[Docket No. 2000–SW–37–AD; Amendment 39–12449; AD 2001–20–03]

#### Airworthiness Directives; Bell Helicopter Textron Canada Model 206L–4 Helicopters

**ACTION:** Final rule.

**Figure 1**

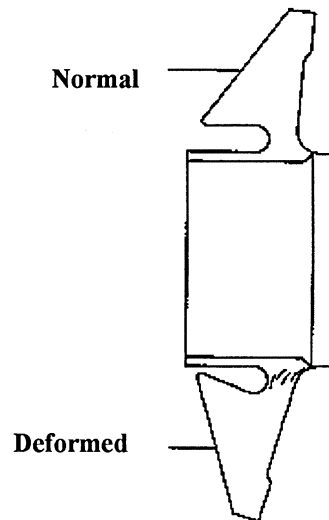
(b) Before each engine start, check the indicator for damage in accordance with Figure 1 of this AD. If damage is found, before further flight, replace the damaged indicator with an airworthy indicator, and replace the tail rotor yoke, P/N 406-012-102-107, with an airworthy tail rotor yoke.
